World Forum for Harmonization of Vehicle Regulations**Working Party on Lighting and Light-Signalling****Eighty-fourth session**

UN Regulation No. 48 (Installation of lighting and light-signalling devices):**Proposals for new series of amendments to UN Regulation No. 48****Proposal for a new [08] series of amendments to UN
Regulation No. 48****Submitted by the expert from Japan***

Model A

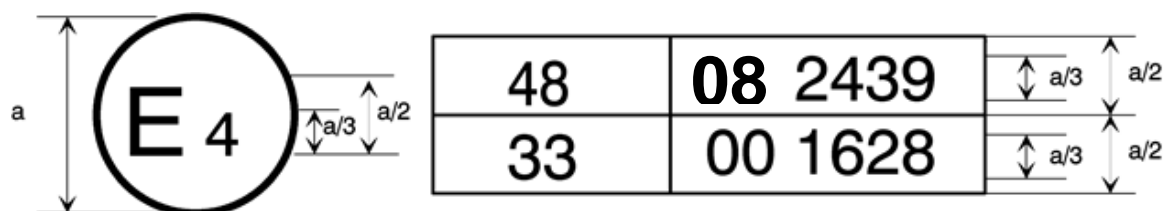
The above approval mark affixed to a vehicle shows that the vehicle type concerned has, with regard to the installation of lighting and light-signalling devices, been approved in the Netherlands (E4) pursuant to UN Regulation No. 48 as amended by the [08] series of amendments. The approval number indicates that the approval was granted in accordance with the requirements of UN Regulation No. 48 as amended by the [08] series of amendments.
